MIL-R 83536/2
AMENDMENT 1
15 December 1995

MILITARY SPECIFICATION SHEET

RELAYS, ELECTROMAGNETIC, ESTABLISHED RELIABILITY, DPDT, LOW LEVEL TO 5 AMPERES, PERMANENT MAGNET DRIVE, HERMETICALLY SEALED, ALL WELDED, TRANSIENT SUPPRESSED DC COILS

This amendment forms a part of MIL-R-83536/2, dated 27 March 1992, and is approved for use by all Departments and Agencies of the Department of Defense

CIRCUIT DIAGRAM (NO MOUNT, RVFM, HFH AND TRACK MOUNT A) (OPTIONAL INTERNAL DIODE CONFIGURATION) .

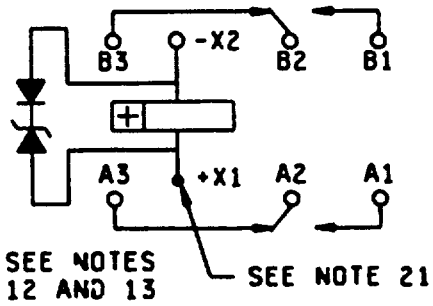
FIGURE 1, add the following circuit diagram between the existing diagrams
